October 20, 2026

ADDENDUM NO. 6

SHREWSBURY-WORCESTER
Bridge Preservation, S-14-021=W-44-115, I-290 (EB and WB)
over Lake Quinsigamond and Lake Avenue North

PROPOSED TROUGH ALTERATION AT EAST ABUTMENT

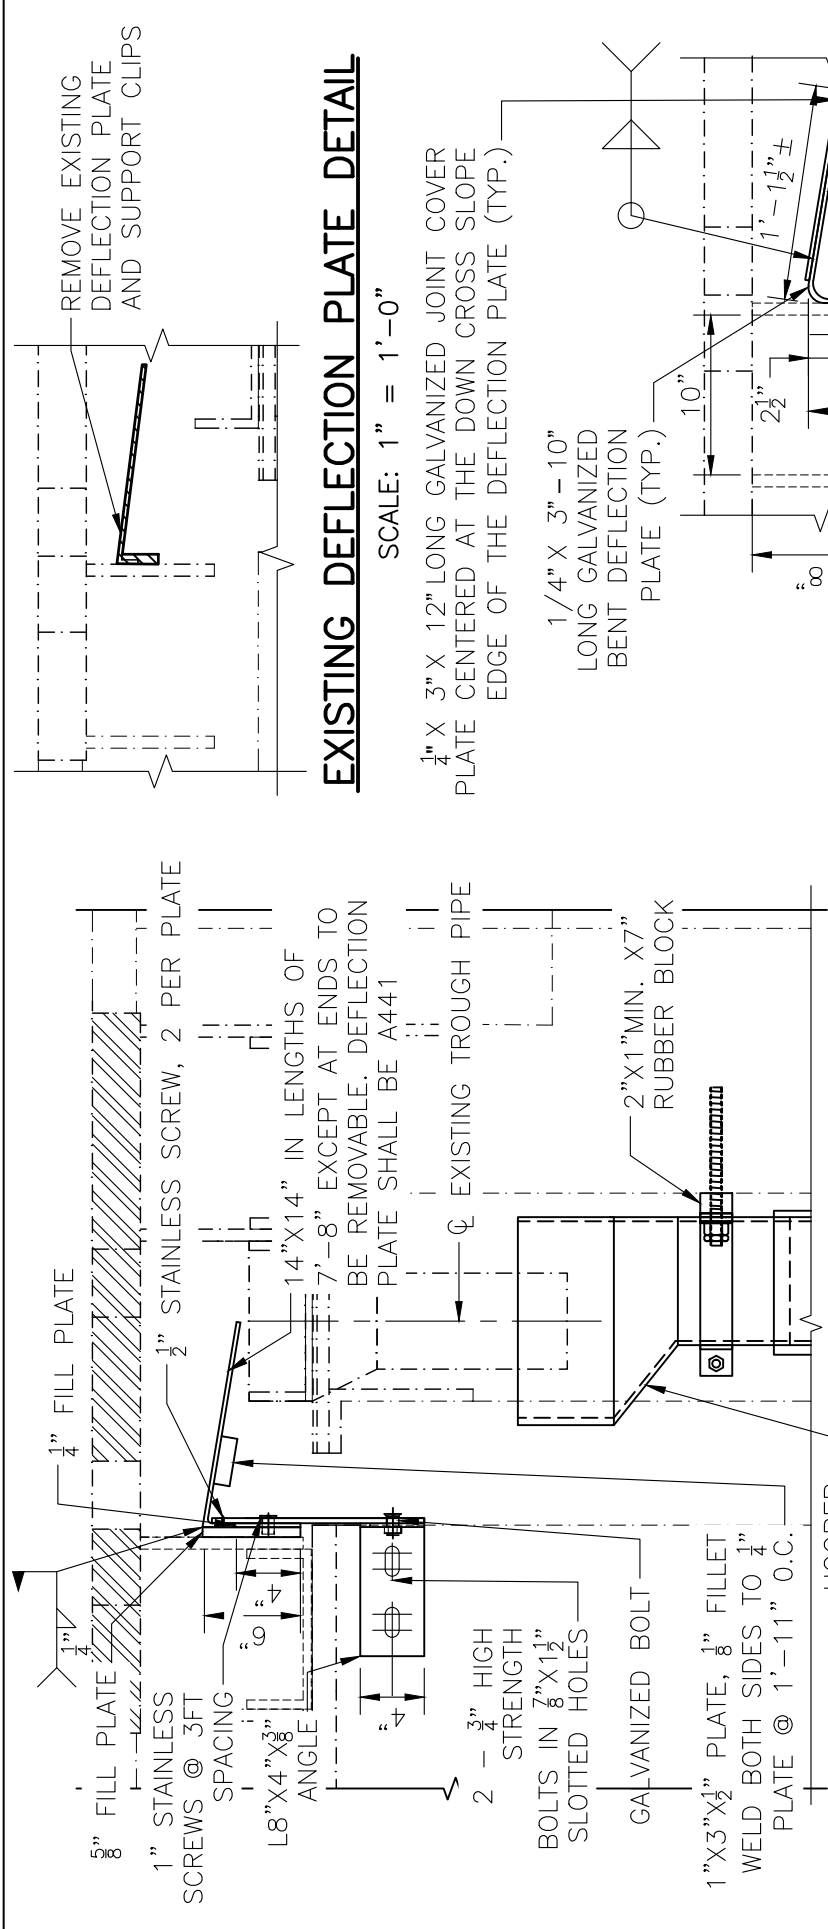
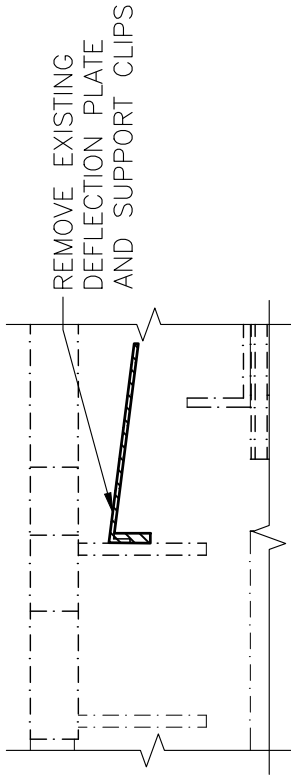
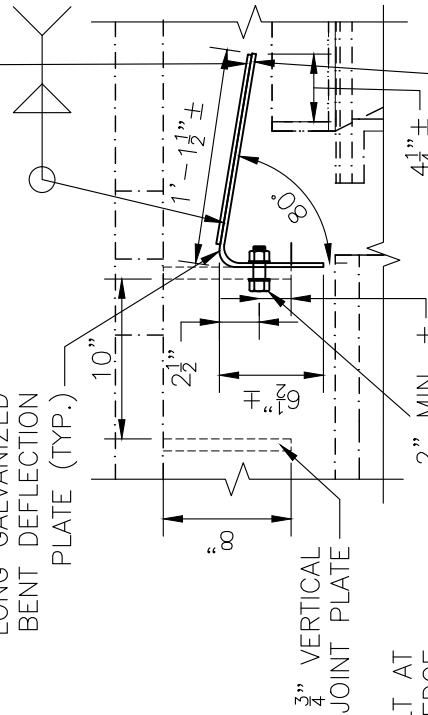
The proposed trough alteration at the east abutment as shown on sketch sheet 26 of 87 details the installation of runoff deflection plates underneath the finger joint. Due to the narrow gap of 5” +/- between the bridge deck end and the abutment there is not enough room to physically install, fasten and weld the new deflection plate as shown sketch sheet 26 of 87 from the underside of the bridge. The original construction of the finger joint does not provide the ability to remove the finger joints to install the new deflection plates from the top due to the joint system being a one-piece curb to curb welded assembly which is cast into the deck and abutment. Please advise?

The detailing shown reflects the original removable deflection plate design, which is intended to allow for removal of the plate to facilitate system maintenance. However, the Contractor may modify the detailing as necessary to accommodate their means and methods. Such modifications may include reversing the galvanized bolts to improve accessibility, adding bolted supports to eliminate the need for welding, or fabricating the fill plate with welded studs in lieu of the stainless-steel bolts shown, provided the intended functionality and removability of the plate are maintained.

An alternate simplified deflection plate detailing is also provided, see the revised drawing in page A00803 – 28.

ALTERNATE DEFLECTION PLATE DETAIL SHOWN IN SECTION BETWEEN GIRDERS

3/4" DIA. GALVANIZED BOLT AT 12" SPACING AND 6" EDGE DISTANCE TO VERTICAL EDGE, FIELD DRILL HOLES ON EXISTING 3/4" JOINT PLATE AND DEFLECTION PLATE WITH LOW PROFILE MAG DRILL FROM THE BRIDGE SPAN SIDE (TYP.)
